# N5245AS-01A

# S E R V I C E N O T E

## N5245AS PNA Series Microwave Network Analyzers

**Some analyzers are exhibiting unlocked or unlevelled errors or other unexpected digital control faults. Analyzers that experience any of the symptoms listed on page 2 of this document must be inspected for a possible return to Agilent to have the system motherboard replaced.**

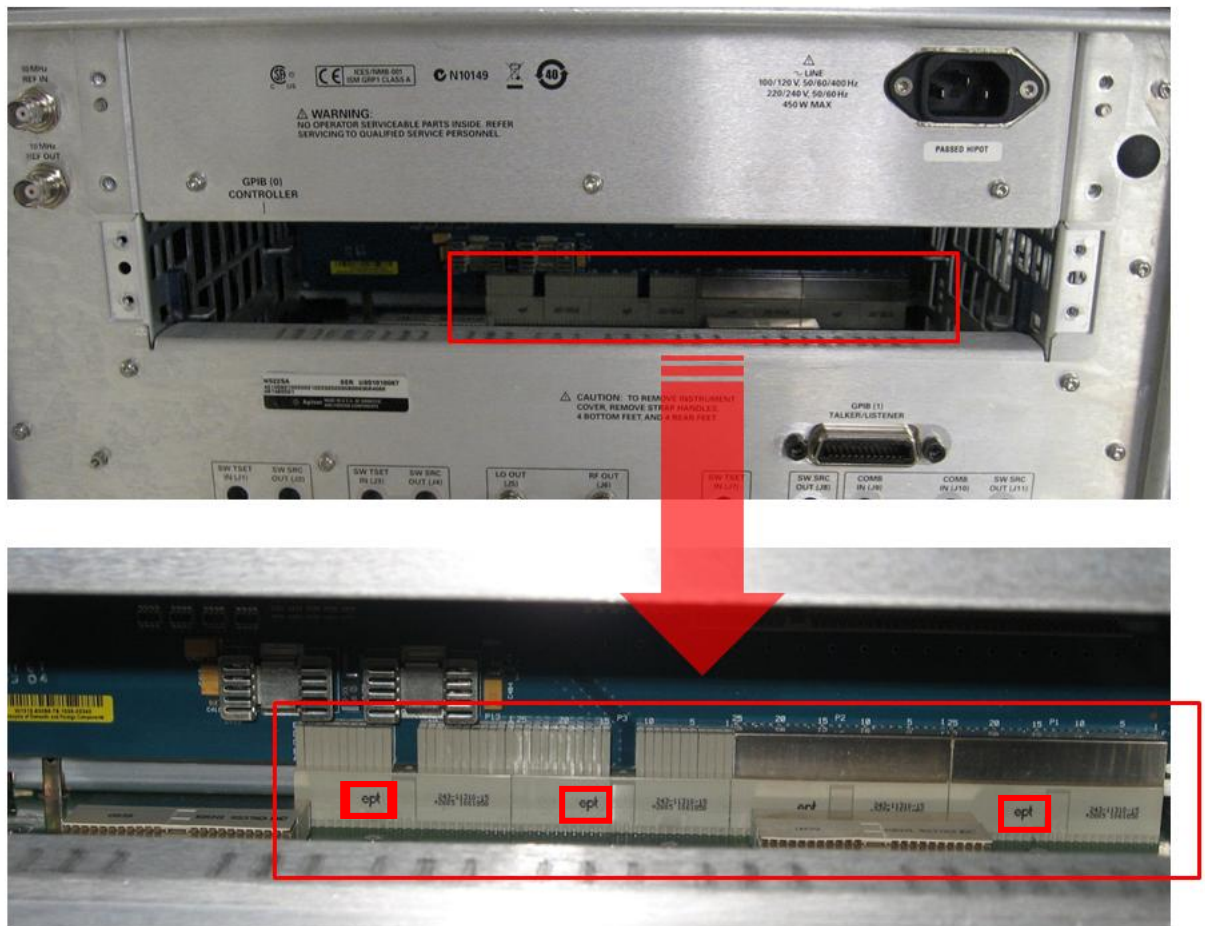
1. Remove the CPU assembly from the analyzer's rear panel. Refer to the PNA Service Guide chapter 7 section titled, "Removing and Replacing the CPU Board Assembly" for removal and reinstallation procedures. To view the online Service Guide, see the numbered list on the next page for instructions.
2. As per the photo below, inspect the system motherboard connector to see if it has one or more "ept" logos.

3. If the connector has one or more “ept” logos, return the analyzer to Agilent for replacement of the system motherboard. If the connector does not have one or more “ept” logos, email [ctd-soco\\_support@agilent.com](mailto:ctd-soco_support@agilent.com), providing the analyzer model and serial number and details of the malfunction symptoms.

4. *For Agilent Service Technicians only:* Only new boards without “ept” logos should be installed. Before installing the new board, look to see if it has one or more “ept” logos. If so, email [ctd-soco\\_support@agilent.com](mailto:ctd-soco_support@agilent.com), providing the analyzer model and serial number. Wait for further instructions in an email reply. New boards without “ept” logos can be installed. For installation instructions, refer to the PNA Service Guide chapter 7 section titled, “Removing and Replacing the System Motherboard.” To view the online Service Guide, see the numbered list on the next page for instructions.
